**AIP SUPPLEMENT
(SUP)****H105/26****Effective: 202607240100 UTC**

**BURKETOWN AERODROME (YBKT)
INTERIM RUNWAY****1. INTRODUCTION**

1. Site Plan

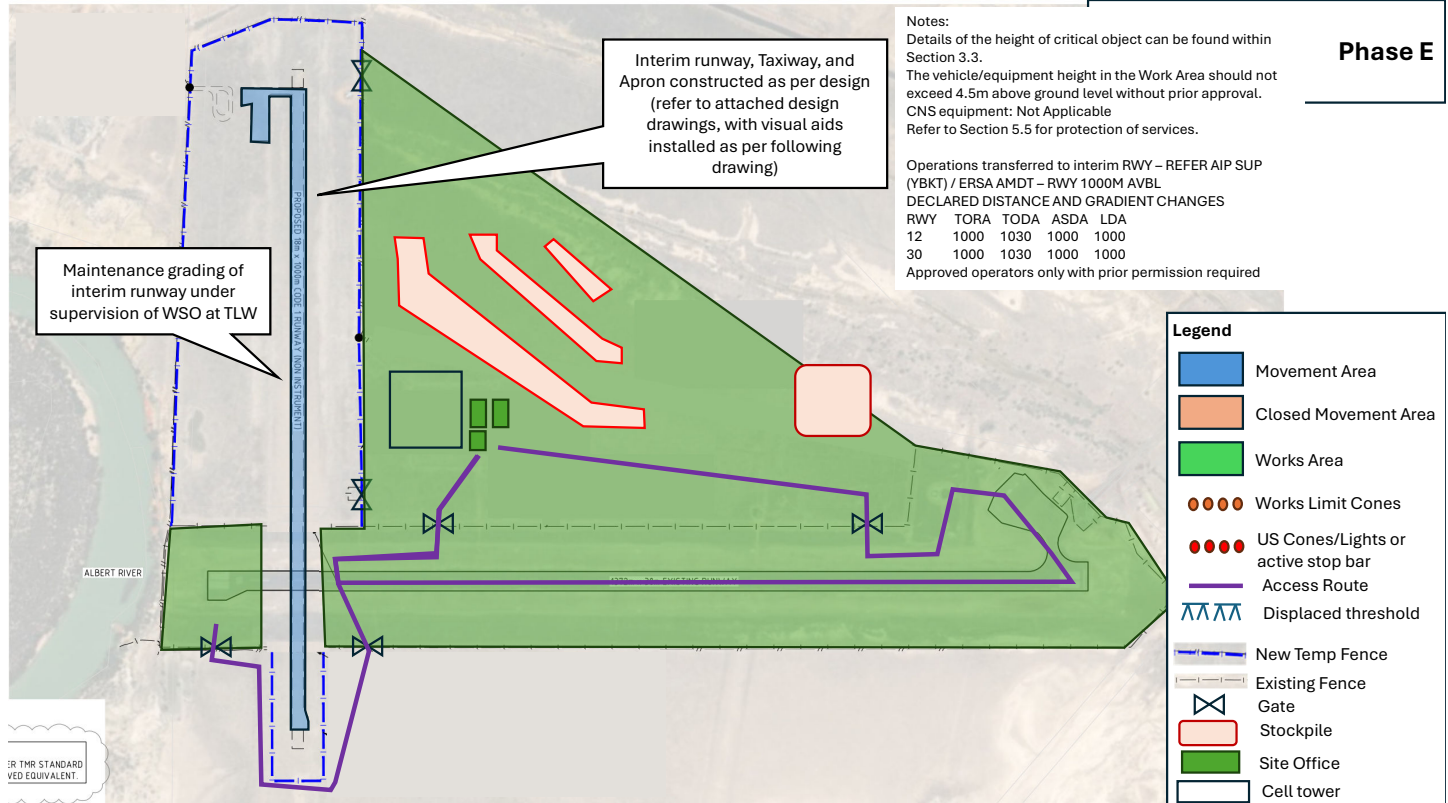
- 1.1 This AIP SUP provides notification of runway, taxiway and apron closures, and details of interim runway and facilities availability at Burketown Aerodrome (YBKT), to facilitate repairs following significant flood damage.
- 1.2 All existing manoeuvring areas will be closed from June to October 2026.
- 1.3 Refer to MOWP YBKT26/01 for information in relation to the construction works underway. The MOWP is available on the Burke Shire Council website or by email request to aakrami@burke.qld.gov.au.

- 2.1 Whilst the RWY works are underway all current manoeuvring areas will be closed to aircraft during the period listed in para 1.2. These areas include:
 - a) RWY 03/21
 - b) TWY A and Apron
- 2.2 An interim RWY 12/30, taxiway and apron have been constructed to allow operation of medical emergency aircraft and essential aircraft operations with prior approval only. The new facilities include:
 - a) RWY 12/30
 - b) Apron and TWY access
 - c) Refueling facilities - AVGAS and JET-A1
